LETTER REGARDING SIX REPORTS WRITTEN BY ABB ENVIRONMENTAL ABOUT SITE
11 NSB KINGS BAY GA
2/9/1995
U S DEPARTMENT OF THE INTERIOR

USGS comments on position of confining bed in vicinity
of Kings Bay site 11 and on ABB reports of July 1994

Figure 1.

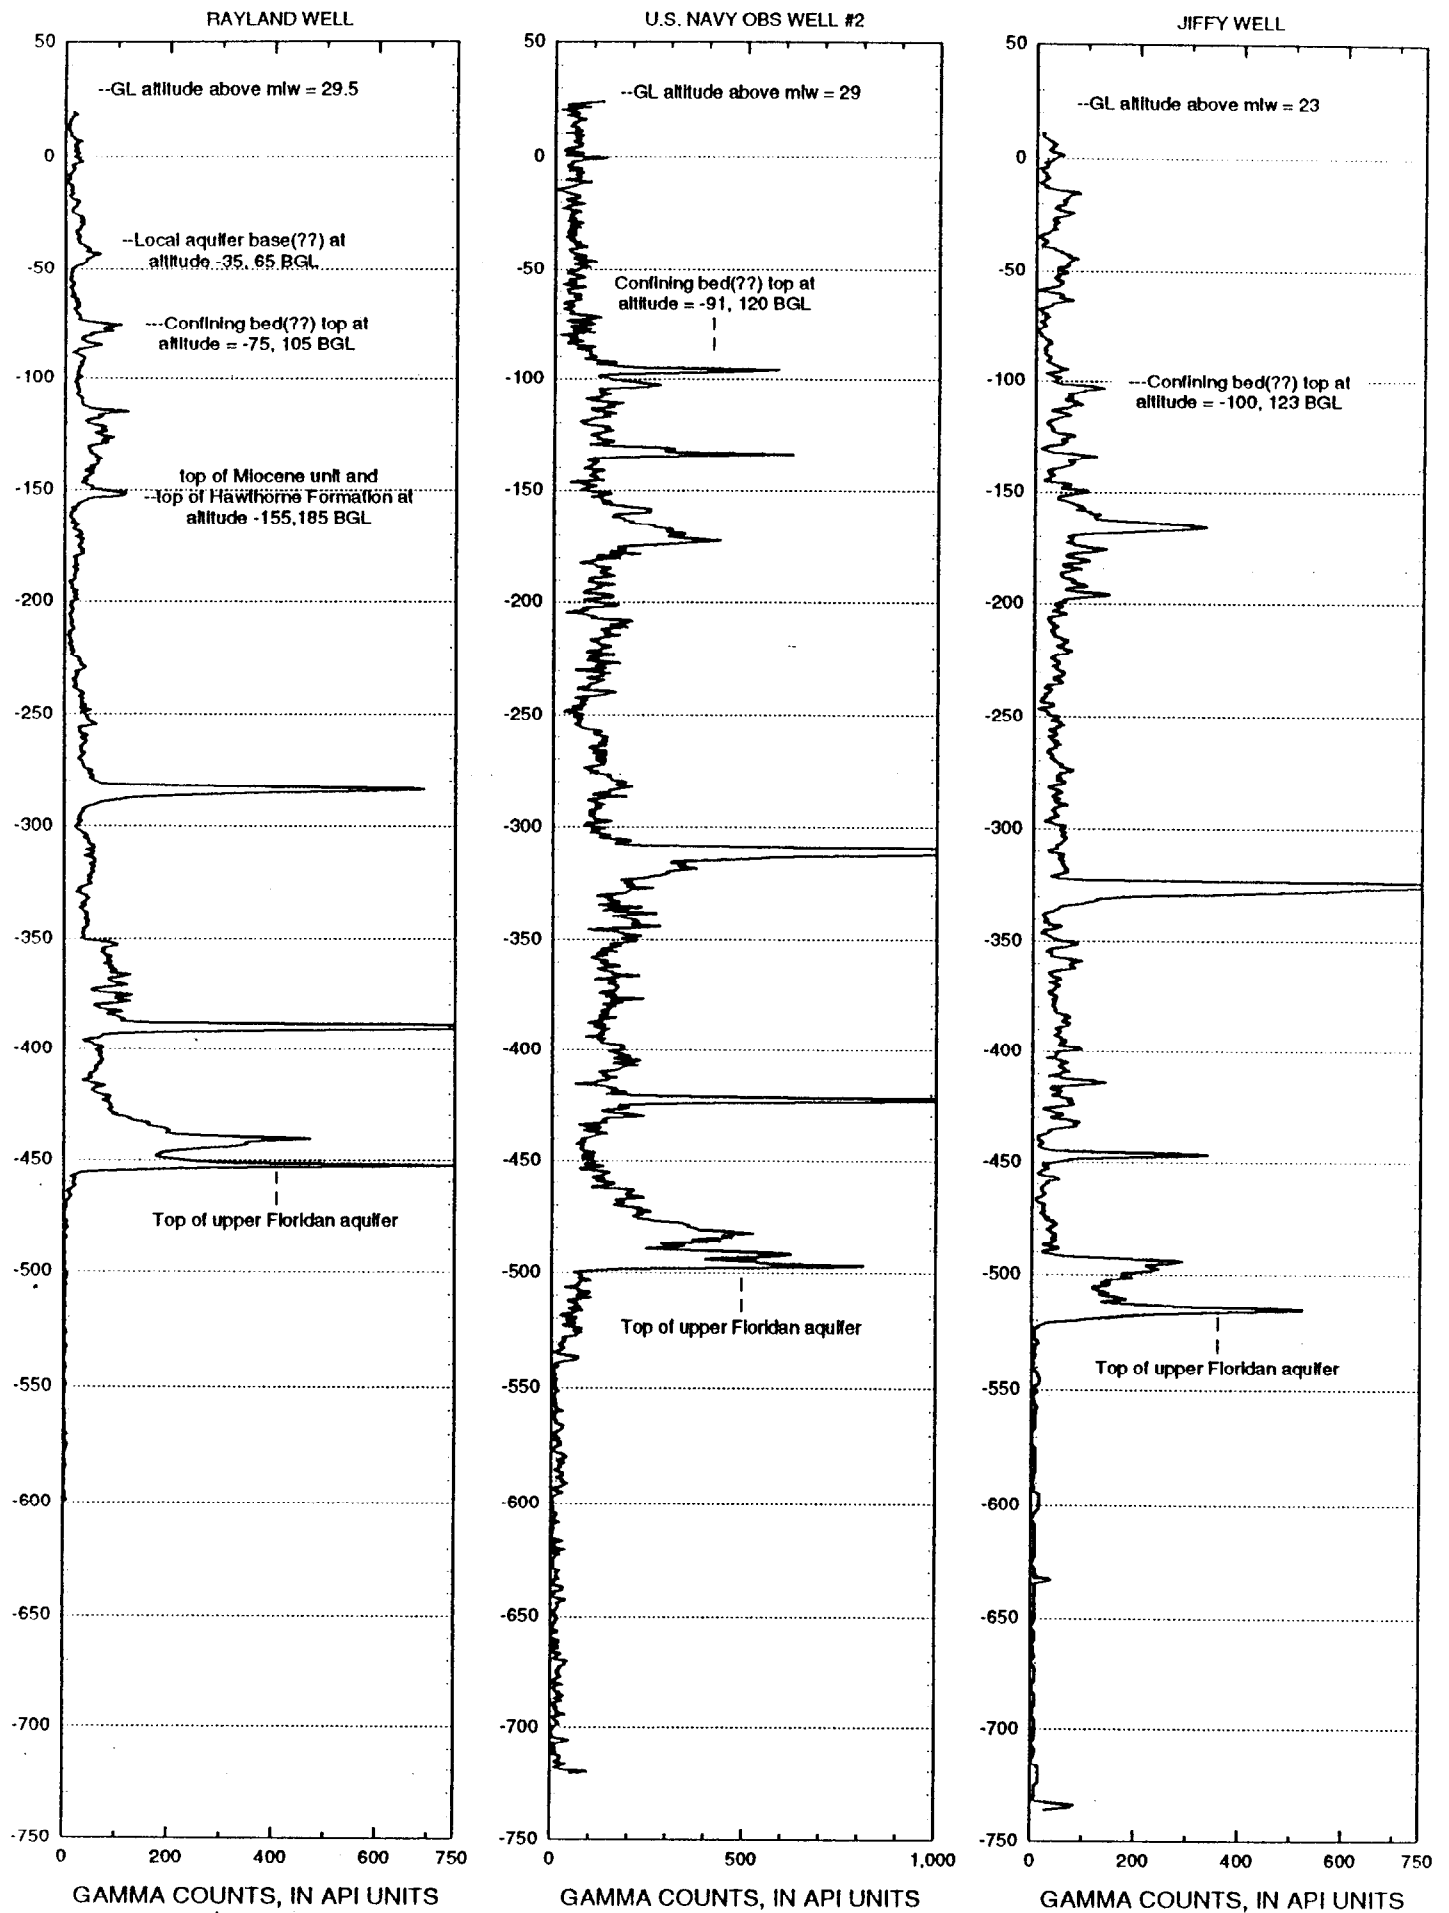
Gamma radiation logs of three wells (fig. 1) illustrate the stratigraphy in the Kings Bay area. The Rayland well is located adjacent to Georgia highway spur-40, at the entrance to the Crooked River Plantation subdivision. The USGS logs from the Rayland well were described in a letter to David Driggers, Southern Division Naval Facilities Engineering Command, dated May 23, 1994. The U.S. Navy Observation Well #2 is located on the Kings Bay submarine base, about 1/2 mile east of the visitor's center at the base entrance. The Jiffy well is located in St. Marys, at the intersection of Georgia highway spur-40 and Georgia highway 40.

The high count rates shown in the Rayland well at altitudes -280, -390, and -450 feet are due to phosphatic sand. However, above altitude -70 feet most zones of higher count rates correspond to strata that ABB describe as clay, and the lower count rates correspond to their descriptions of sand. Therefore, the relationship of higher count rates in clays is assumed for the sections of the gamma logs shown in figure 1 from ground level to the obvious phosphatic sand unit at altitude -280 feet. A low concentration of gamma-emitting isotopes accounts for the very low gamma count rates in the limestone of the upper part of the Floridan aquifer.

The gamma log of the Rayland well illustrates the following. The top of the upper Floridan aquifer is at altitude -452 feet, which corresponds to a depth of 481 feet below ground level (BGL). The top of the Miocene unit corresponds to the top of the Hawthorn Formation in Georgia (Clarke and others, 1990, plate 1), and is at altitude -155 feet (185 feet BGL). Relatively higher gamma counts at altitude -75 feet (105 feet BGL) may represent a confining bed that is evidently continuous to the Navy#2 well at altitude -91 feet, and to the Jiffy well at altitude -100 feet. The relatively higher gamma counts at altitude -35 feet (65 feet BGL) could also represent a clayey confining bed, and possible local restriction to flow at site 11. This bed at altitude -35 feet is called "local" because it is not apparent at the Navy#2 well, and may or may not, correspond to strata with higher count rates at the Jiffy well.

The top of the Hawthorn Formation is determined by stratigraphic correlations, and is defined as the top of the Miocene unit on the south Georgia coast. The top of the Hawthorn Formation is about 100 feet deeper (fig. 1) than the approximate 92-foot depth described by ABB (Technical Memorandum of Field Program, July 1994, p. 4-14), or the approximate 80-foot depth described by ABB later in the same report (p. 5-1).

Figure 2. Hydraulic gradient in vertical at well clusters, Kings Bay Navy Base. Well construction and water-level data from ABB report, July 1994. Upper number is hydraulic head difference at each well in a cluster, and lower number is gradient of vertical flow component through indicated interval.

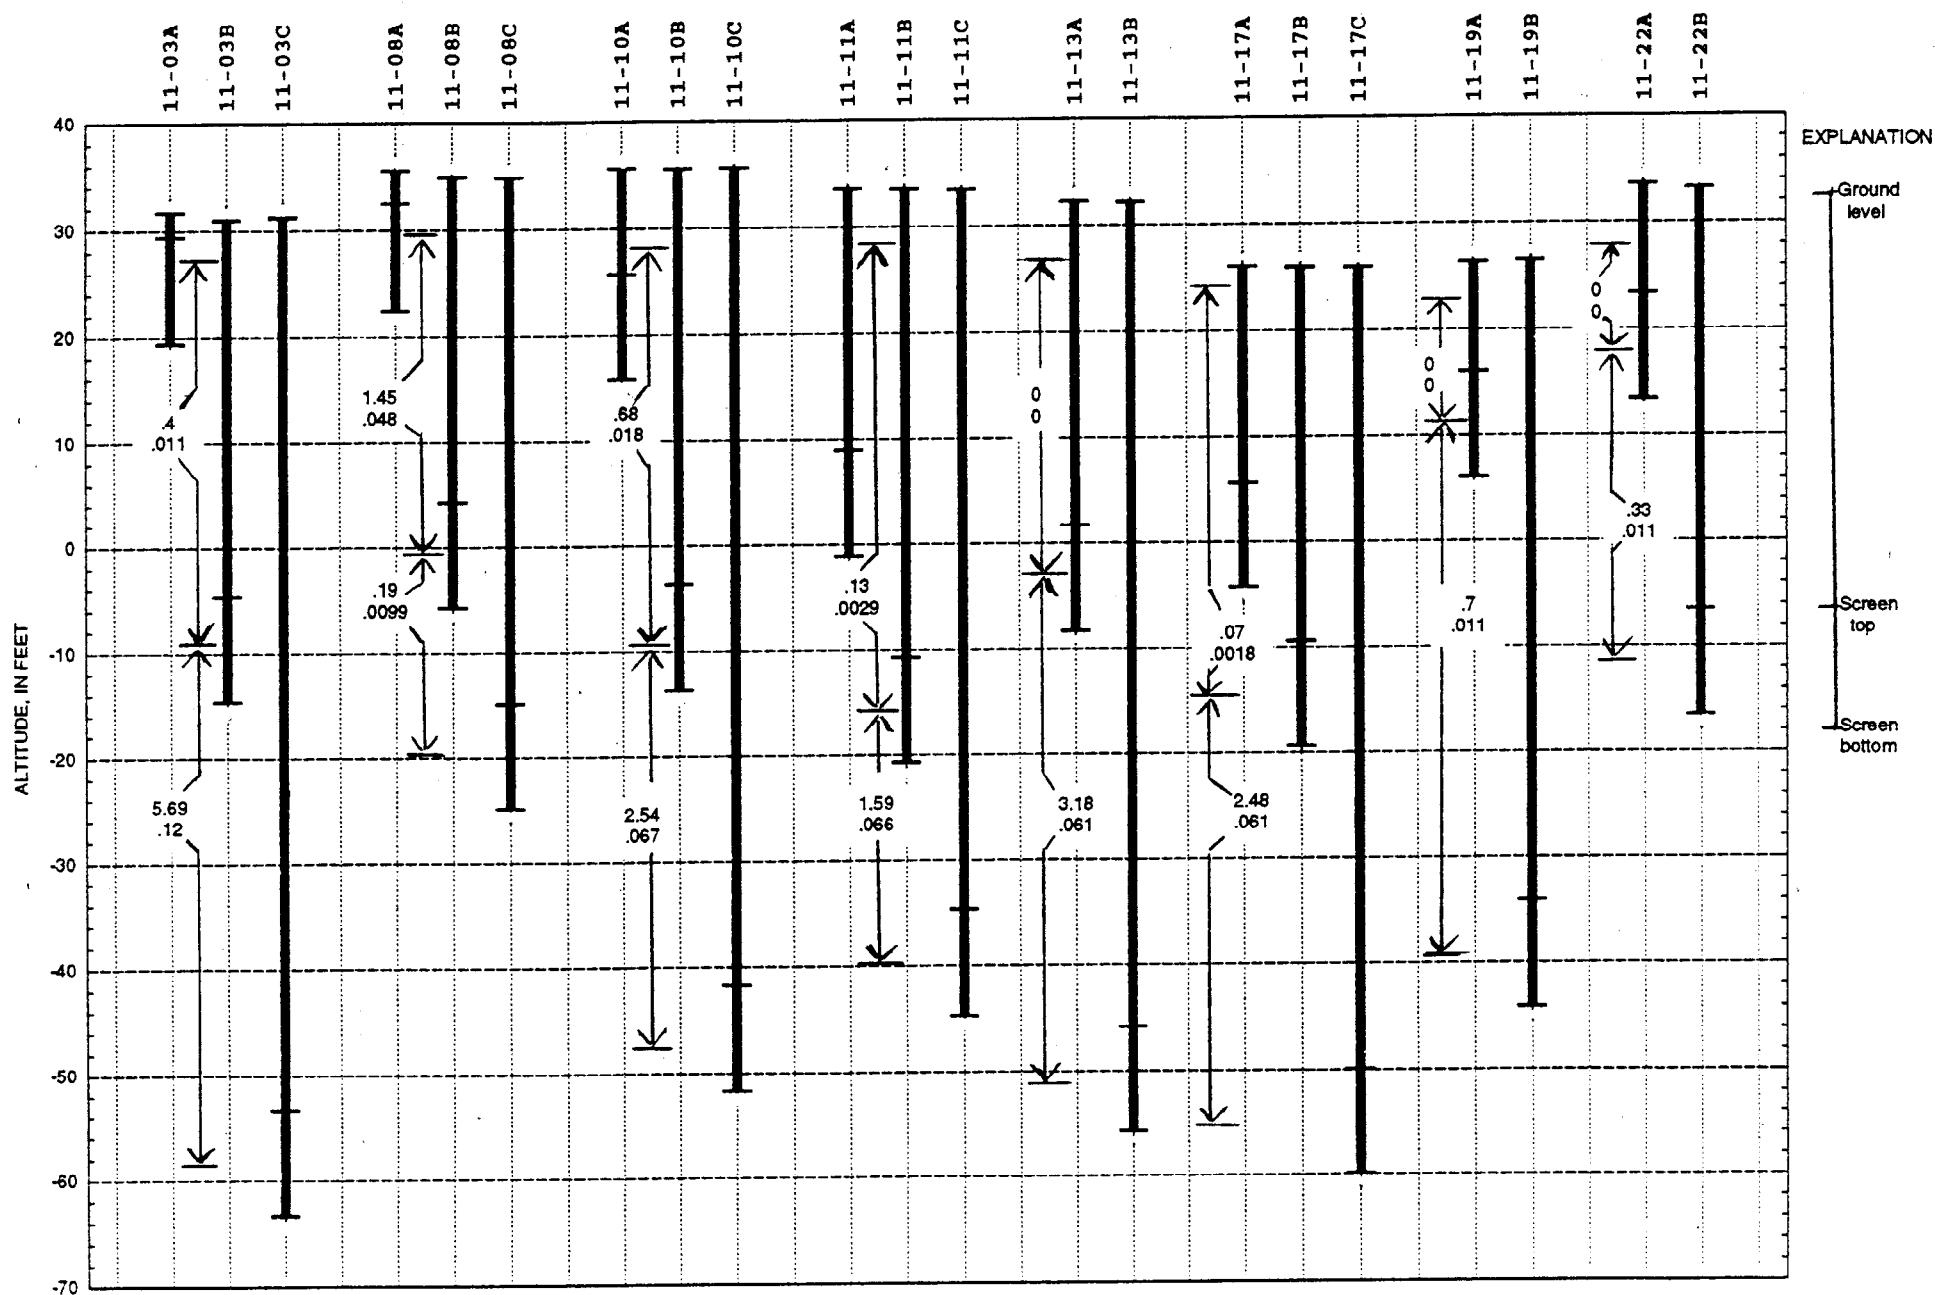
The gradients in the vertical at the site 11 well clusters (fig. 2) were computed by taking the ratio of hydraulic head difference (upper value at each interval shown) to thickness of aquifer over which the head difference is measured (lower value at each interval shown). The upper aquifer thicknesses were taken from the water table (assumed to be the shallowest water-level measurement) to the mid-points of the upper well screens. The lower aquifer thicknesses were taken between the mid-points of the well screens. At two-well clusters, the head loss between the shallower water-level measurement and the position of the shallower well screen was assumed to be zero.

Heads at all well clusters decreased with depth, indicating a downward component of flow. An approximate 3- to 5-fold increase in head gradients is apparent below altitude of about -35 feet, as summarized in table 1. The increased gradients indicate increased resistance to ground-water flow.

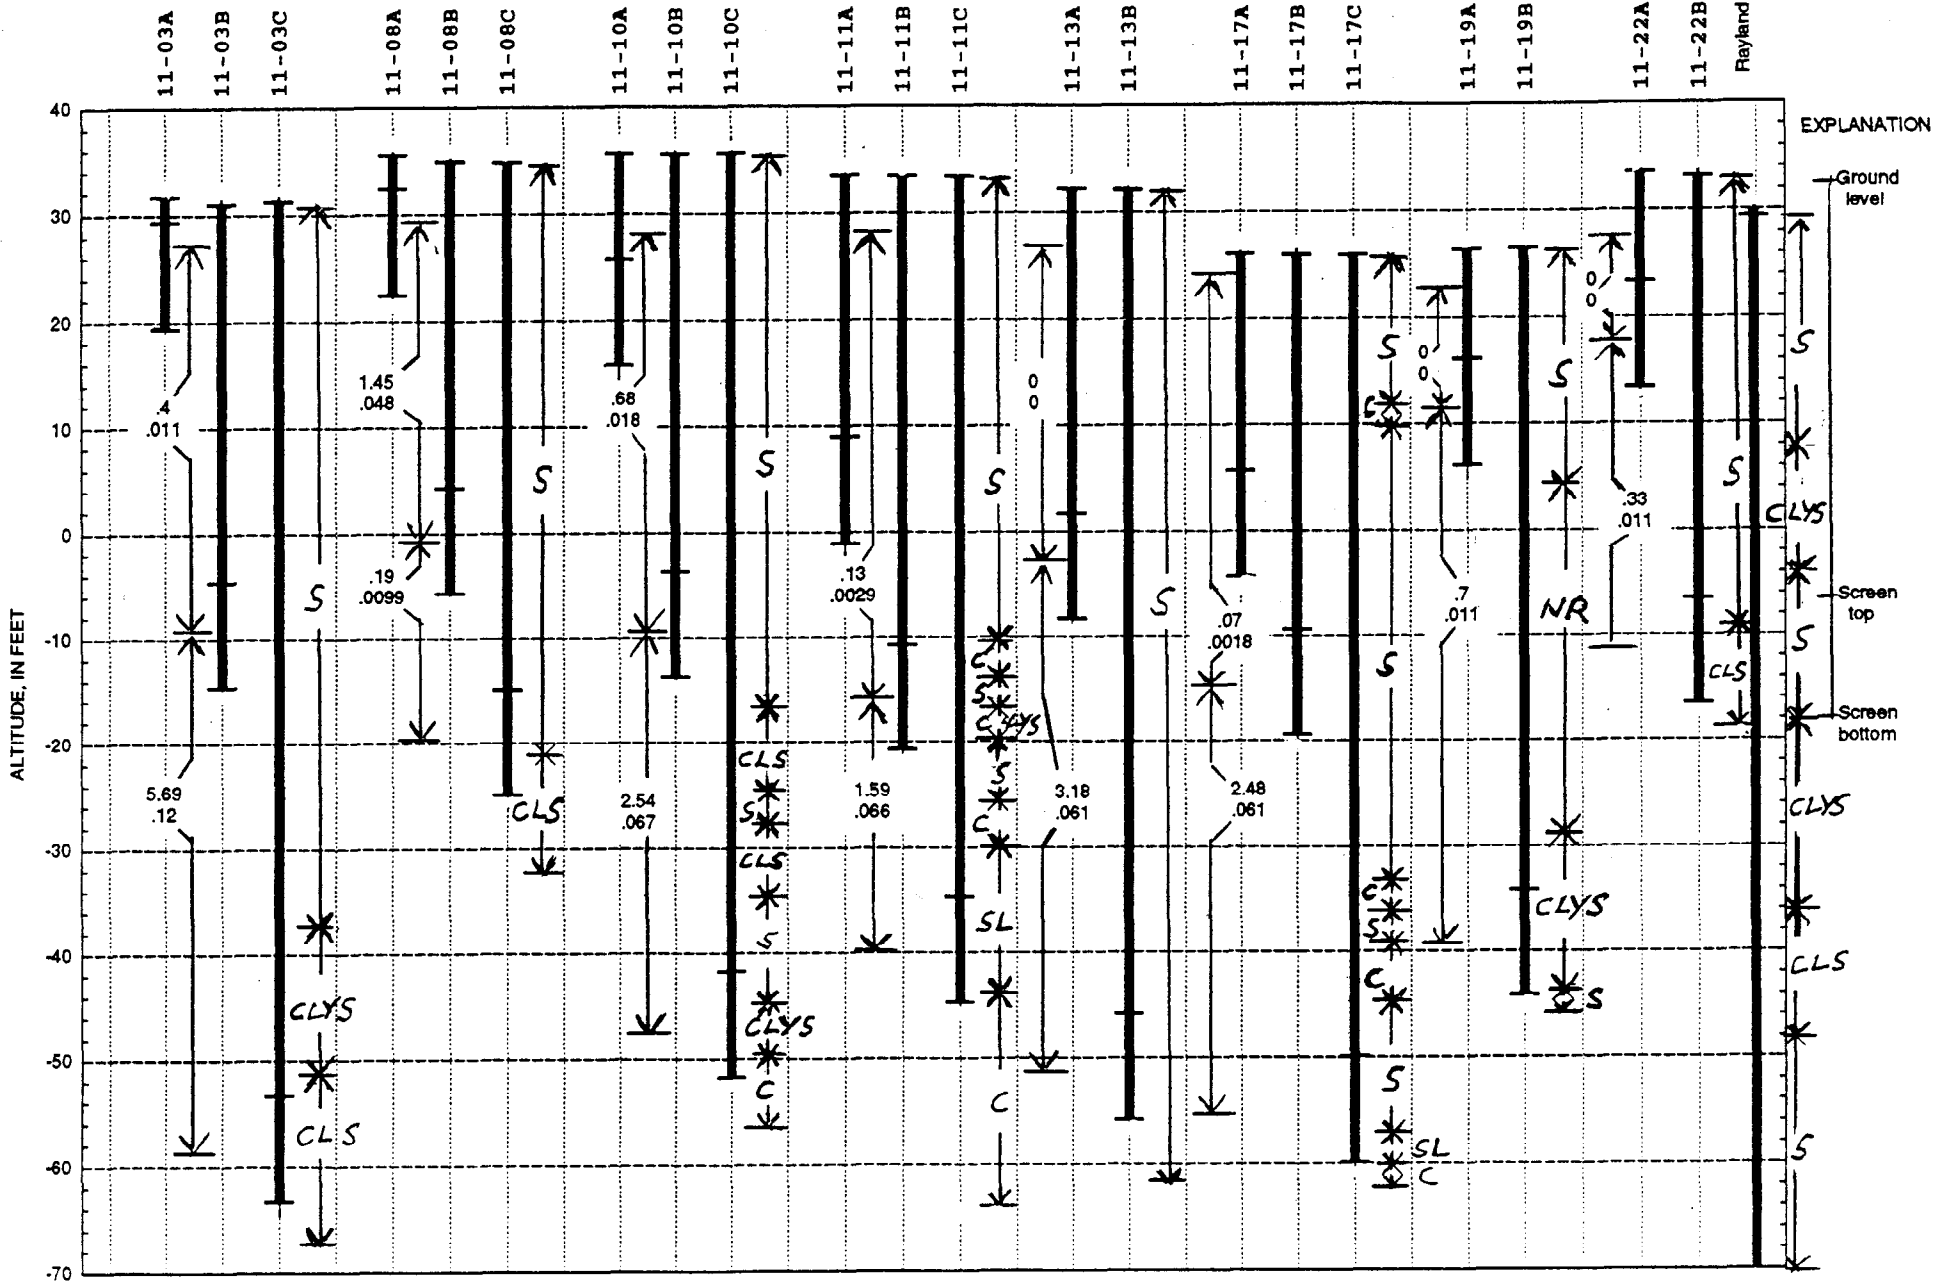
The gradients in the vertical are combined with summaries of ABB soil-sample descriptions, and with USGS interpretations of lithology from gamma logs at the Rayland well (fig. 3). "Summaries" mean that beds described by ABB (Technical Memorandum of Field Program, July 1994, appendix A) of less than about 2-foot thickness are not shown. Lithologic descriptions for samples from most well clusters show a change from sand to clay-sand interbeds, or to clay beds, below an altitude of about -35 feet. The clay-sand interbeds and clay beds probably cause the increase in hydraulic gradient in the vertical.
